P 515210-B

ON-SITE SEWAGE DISPOSAL SYSTEM HOWARD COUNTY HEALTH DEPARTMENT BUREAU OF ENVIRONMENTAL HEALTH

SUBDIVISION: The Paddocks LOT NUMBER: 17

ADDRESS: 3801 Headplay Court PROPERTY OWNER: Pulte Home Corp.

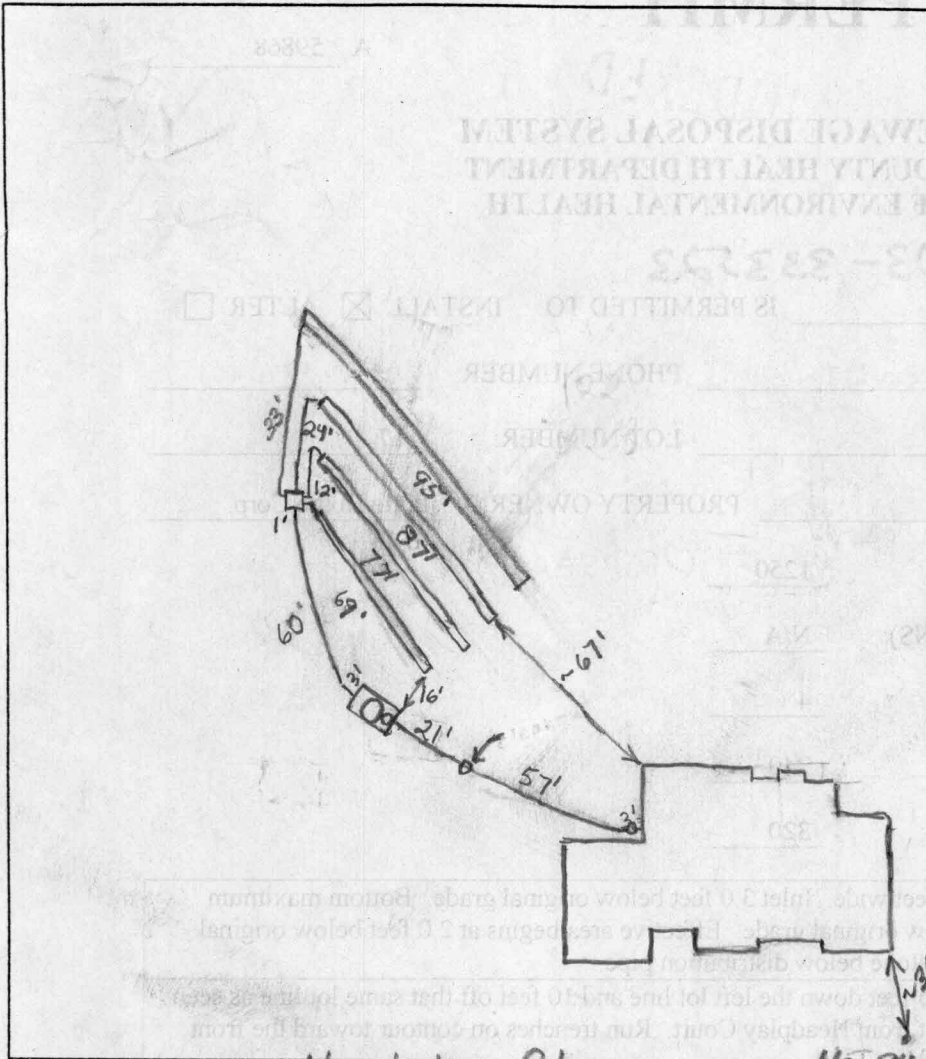
PRE-CONSTRUCTION INSPECTION: 4/27/01 SDA staked - layout confirmed

INSPECTION COMMENTS: 4/30/01 Tank set. Well casing only slightly above grade.
No top visible. No cap on well. (BB) 5/1/01 Left message with Joel -
superintendent - about well. System satisfactory. O.K. to cover. (BB)

OK to install system as specified. DKC
